HISTORIC PRESERVATION BOARD  
AUGUST 20, 2008  
1255 PARK AVENUE, ROOM 205  
6:00 PM

# Historic Preservation Board Staff Report

**Author:** Katie Cattan  
**Subject:** 429 Woodside Avenue  
**Date:** August 20, 2008  
**Type of Item:** Advisory

○  
**STREET ELEVATION**  
1/8/08

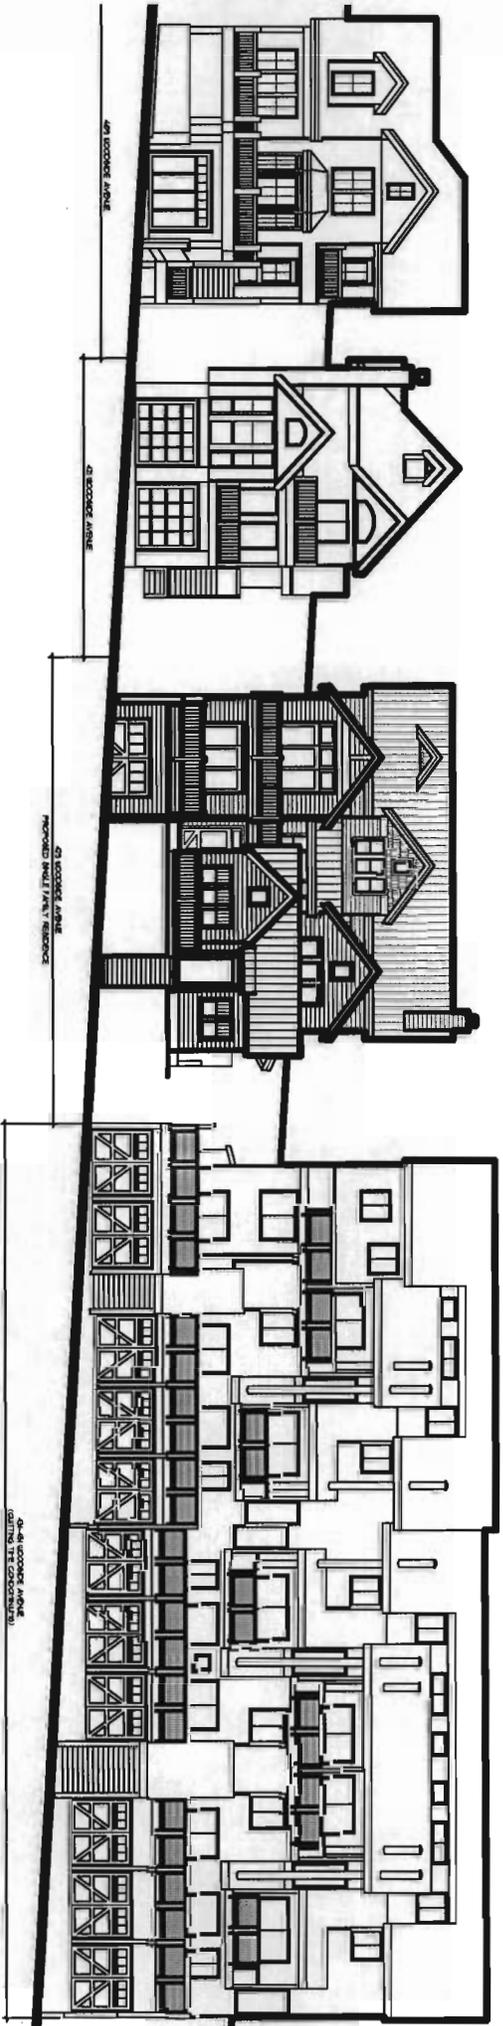
The applicant has provided a streetscape for the property that indicates that it is adjacent to a large contemporary condominium project on the north, and a large contemporary single family home on the south. The proposed design is compatible in size and scale with these two structures.

**WEST ELEVATION**

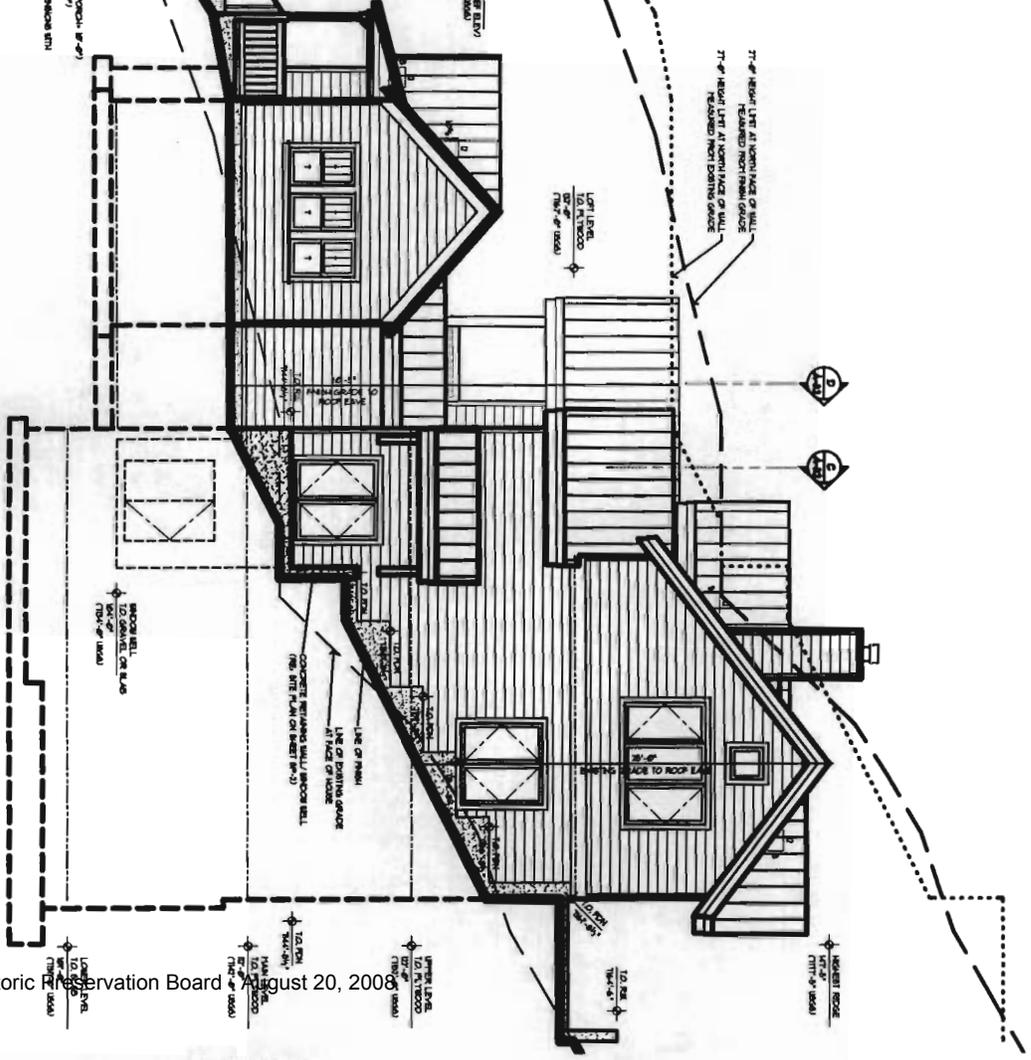
In evaluating the proposed design, staff found that the historic house was both physically and visually distinct from the large addition, thereby maintaining its character in spite of the large scale addition. **Does the HPB concur with this finding?**

The proposed design separates the historic home from the new addition with a small connection between the two. By separating the historic home from the new addition, staff finds that the "historically significant" classification of the home at 429 Woodside Avenue on the Park City Historic Building Inventory will not be compromised. Staff finds that the historic building will continue to demonstrate a quality of significance in local history architecture for the mining era and that the integrity of the history of the location, design, setting, materials, and workmanship will be maintained. By recreating the historic home the building will once again "embody" the distinctive characteristic of the mining era. **Does the HPB concur with this finding?**

SOUTH ELEVATION  
SCALE: 1/4"

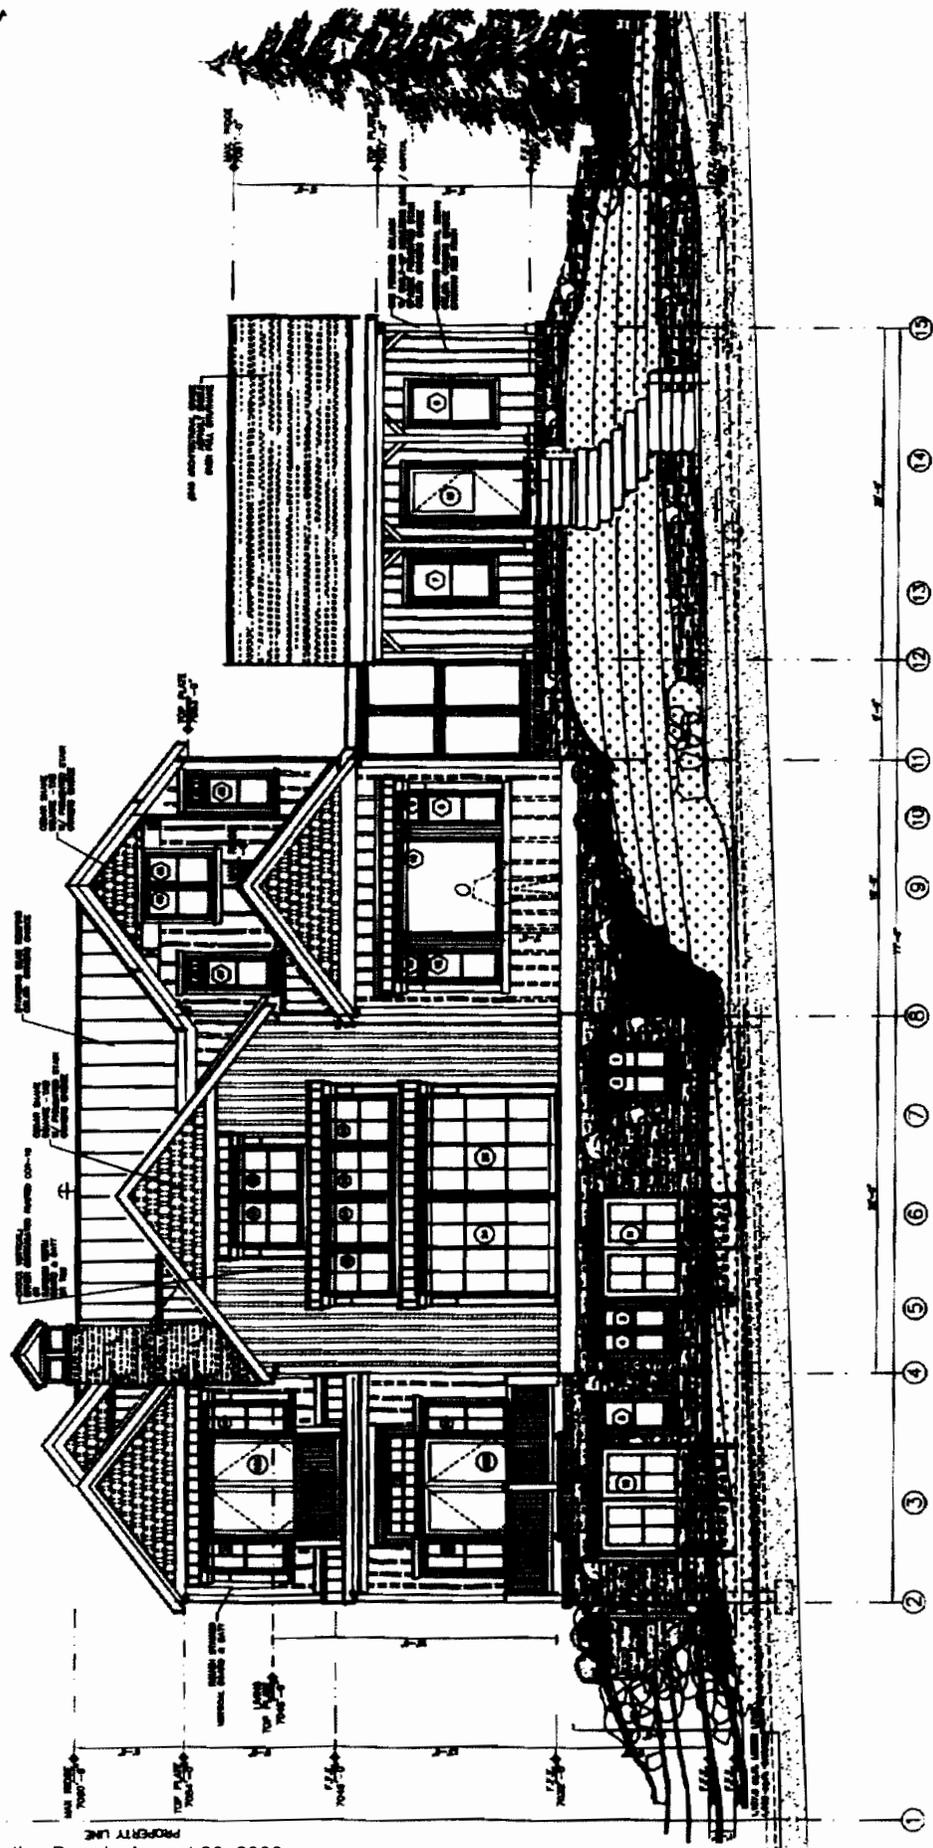
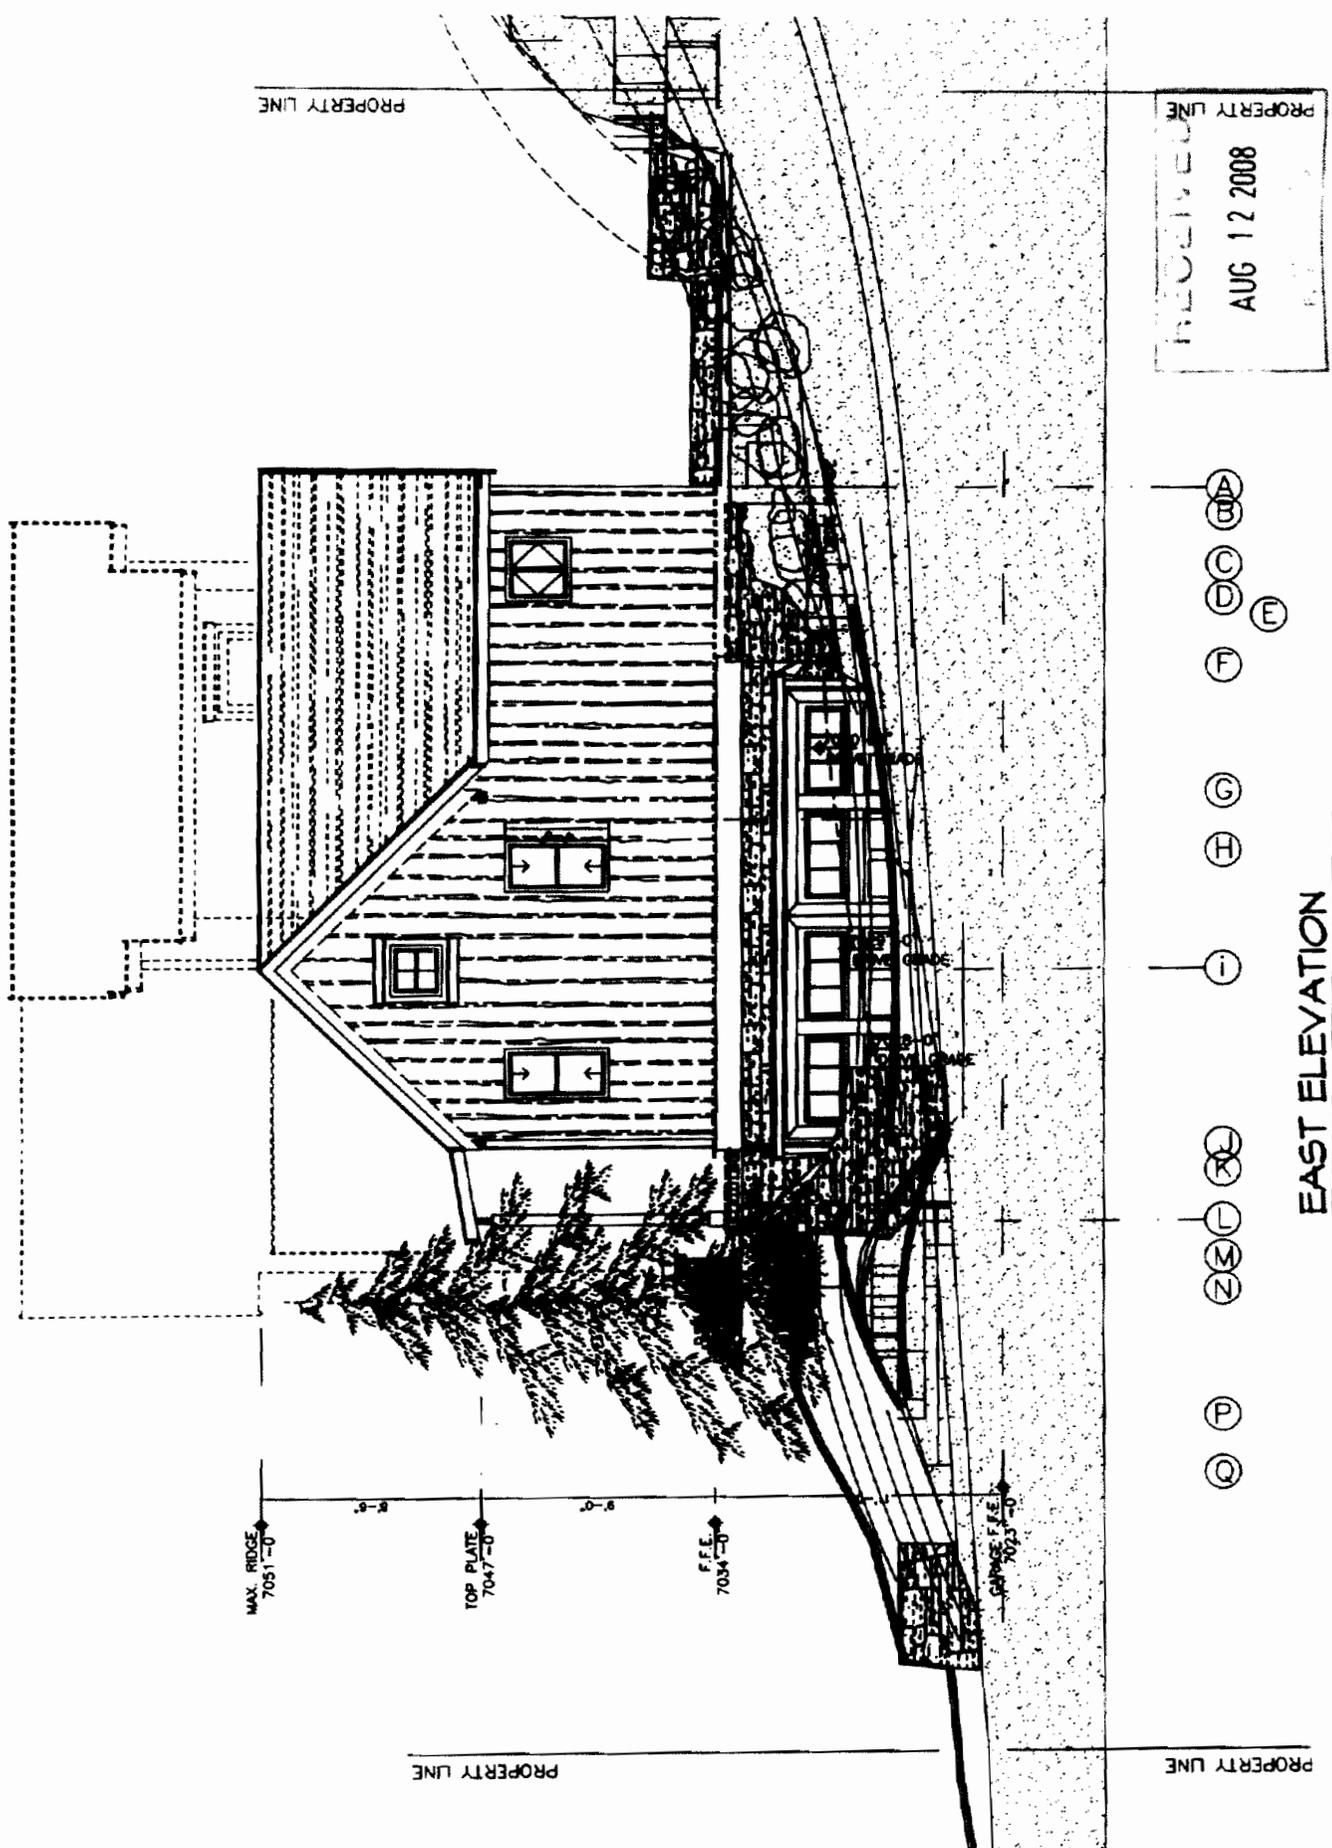
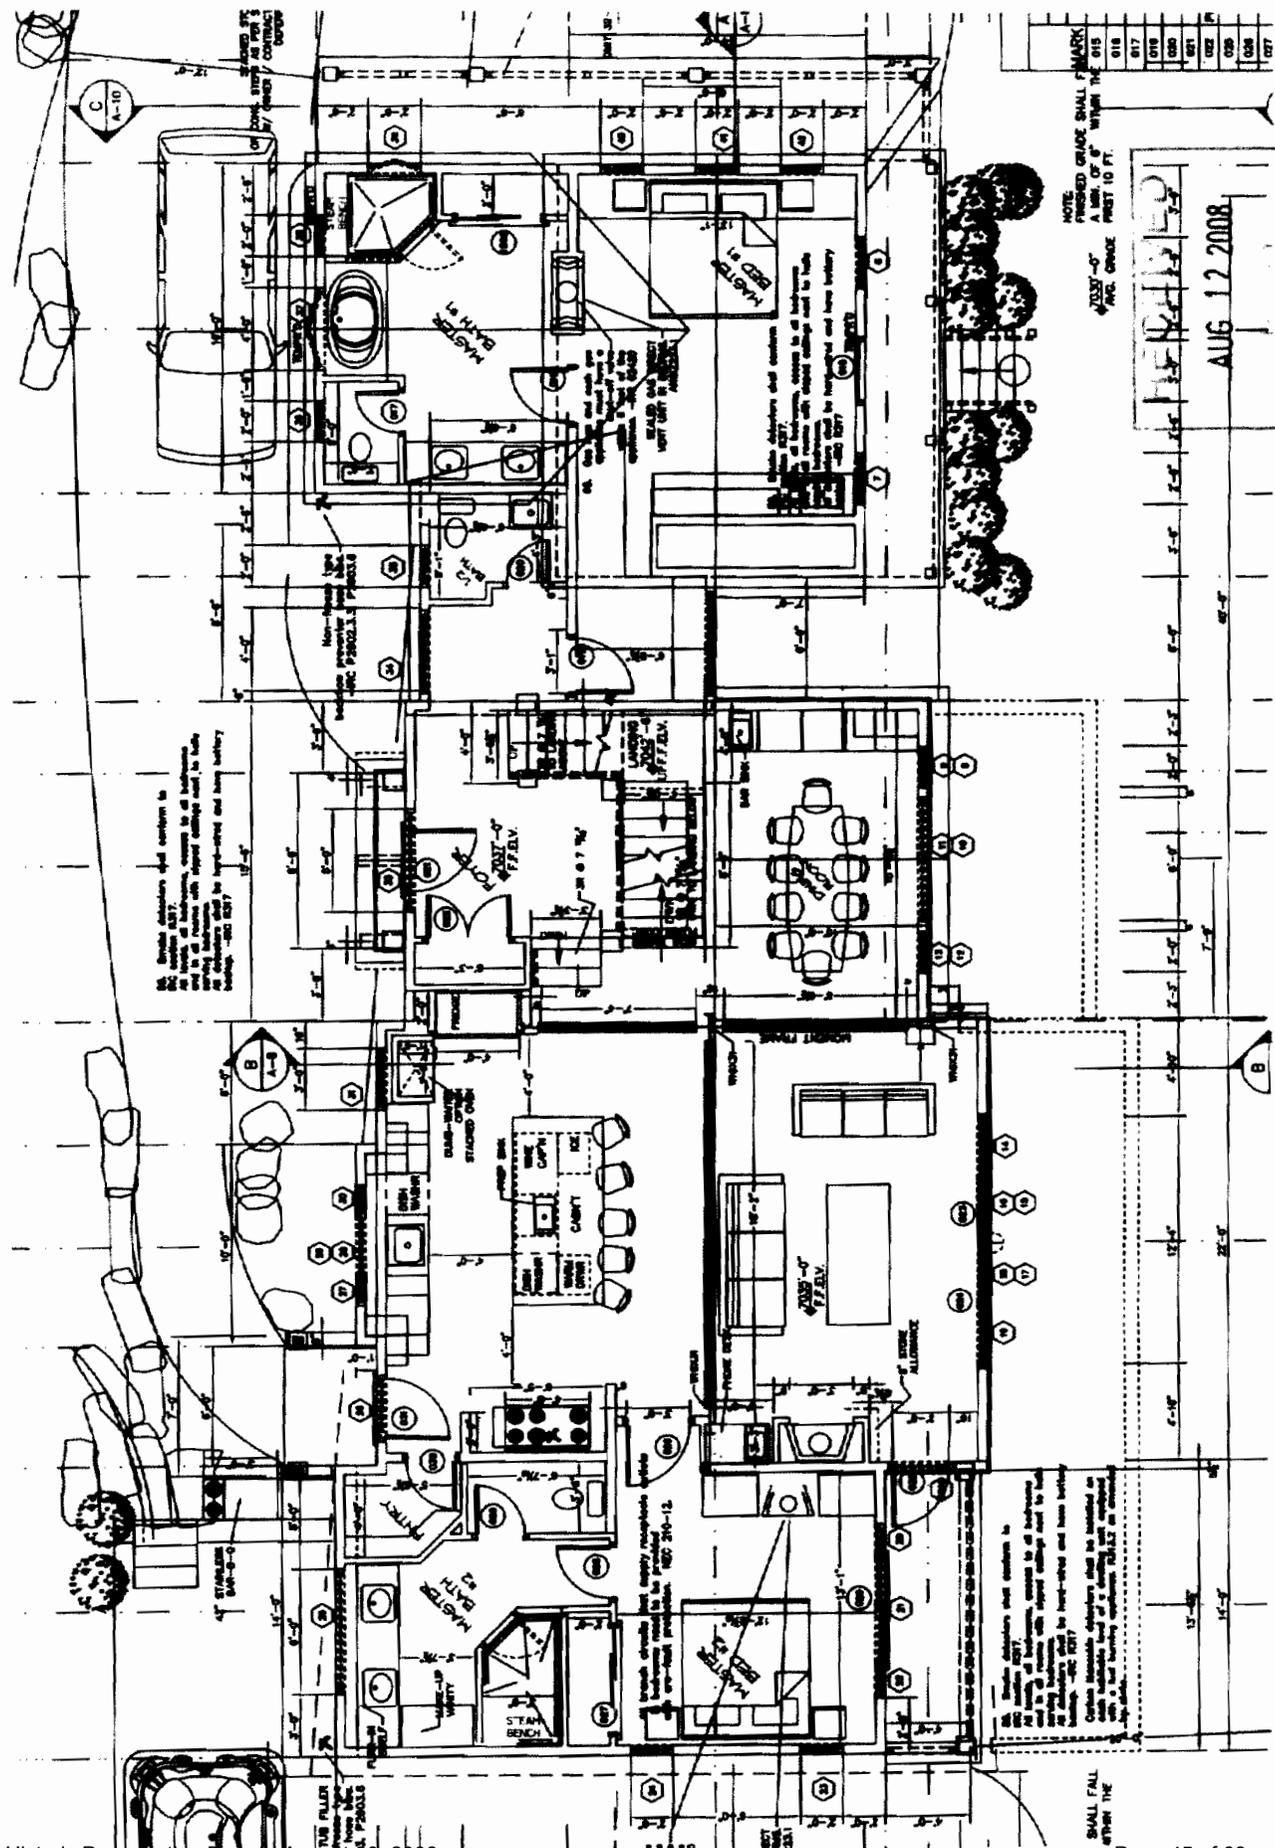
***New construction as proposed-*** *New construction of a large single family house attached to the small historic house as revised minimizes the connection and maintains the context of the structure with the grade of the property. The addition does not cause the historic building to loose the association with the past. **Complies.***

**New construction as proposed-** *The applicant was asked to revise the plans from those submitted for a building permit. Staff requested revisions to the new construction that impacts the distinctive characteristic of the historic house. Revisions are proposed that minimize the connection between the historic house and new construction in order to maintain the context of the historic building to the site. Revisions are proposed to maintain the front porch details, including not having a railing, and not wrapping a porch and railing around the east façade. Revisions to the driveway steepness were made to minimize the degree to which the house is raised (approximately 2' revised from 6' to 7'). Additional retaining walls and details have been added to minimize the garage on a secondary façade. The east elevation of the new construction was modified to remove an upper story deck and roof that negatively impacted the mass and scale of the historic house. Aspects of the addition that impact the historic house allow the mass and scale of the original house to remain and the integrity of the site to be maintained. The new construction is contemporary and does not confuse the period of construction.*

**New Construction as proposed-** *As revised, the plans for the new addition maintain the historic scale of the building by minimizing the connection between old and new, by maintaining the historic context of the building on the site, and by providing off street parking in a manner that minimizing impacts on the primary façade. (See number 2 above). The historic building continues to contribute to the historic value of the property and surrounding area. **Complies.***
